Access Compliance Report

Public Rights-of-Way

(Curb Ramps)

Intersection ID: 49930	Main Street: PAXTON_RUN_RD	Cross Street: CHAMBERLIN_RD	Location: SW
ADA ID: 2BC85D5222B4	Ramp Type: Perp	Initial Pass/Fail: Fail	Overall Compliance: No
Severity Score: 12.5			
Codes/Mitigation Info/Possible Solution		Field Measurements/Component Compliance

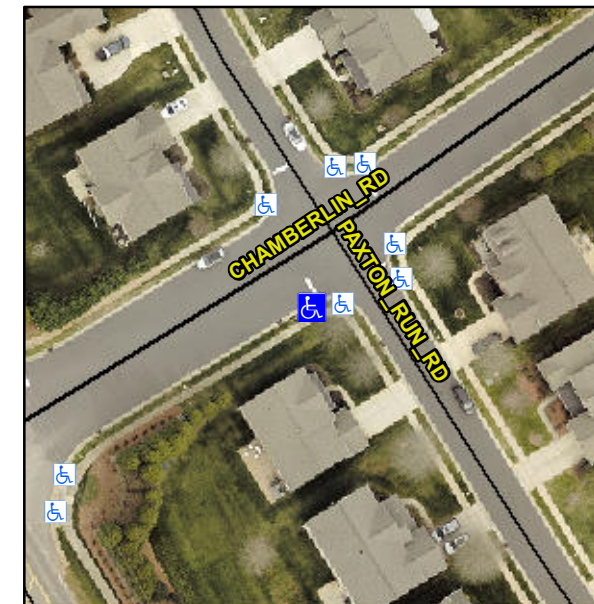
Not Found, R304.2.2

Compliance	Description	Data	Compliance	Description	Data
N/A	Ramp Length (in)	45.0	No	Ramp Slope (%)	10.0
Yes	Ramp Width (in)	48.0	Yes	Ramp XSlope (%)	1.0
N/A	Flare Type LT	N/A	N/A	Flare Type RT	N/A
N/A	Flare Slope LT (%)	N/A	N/A	Flare Slope RT (%)	N/A
N/A	Flare Traversable LT?	N/A	N/A	Flare Traversable RT?	N/A
N/A	Landing Length (in)	N/A	N/A	DWS Provided?	N/A
N/A	Landing Width (in)	N/A	N/A	DWS Contrast?	N/A
N/A	Landing Slope (%)	N/A	N/A	DWS Length (in)	N/A
N/A	Landing X Slope (%)	N/A	N/A	DWS Full Width?	N/A
N/A	Landing Curb? (Y/N)	N/A	N/A	DWS Offset (in)	N/A
N/A	Shared Landing?	N/A			
N/A	Gutter Ponding?	N/A	N/A	Gutter Slope (%)	N/A
N/A	Gutter Lip Ht (in)	N/A	N/A	Gutter X Slope (%)	N/A
N/A	Painted X Walk1?	No	N/A	Painted X Walk2?	N/A
	X Walk 1 Direction	To NW		X Walk 2 Direction	N/A
N/A	X Walk 1 Width (in)	N/A	N/A	X Walk 2 Width (in)	N/A
	X Walk 1 Slope (%)	4.6		X Walk 2 Slope (%)	N/A
	X Walk 1 X Slope (%)	0.0		X Walk 2 X Slope (%)	N/A

Possible Solutions:

Remove & Replace Entire Ramp.
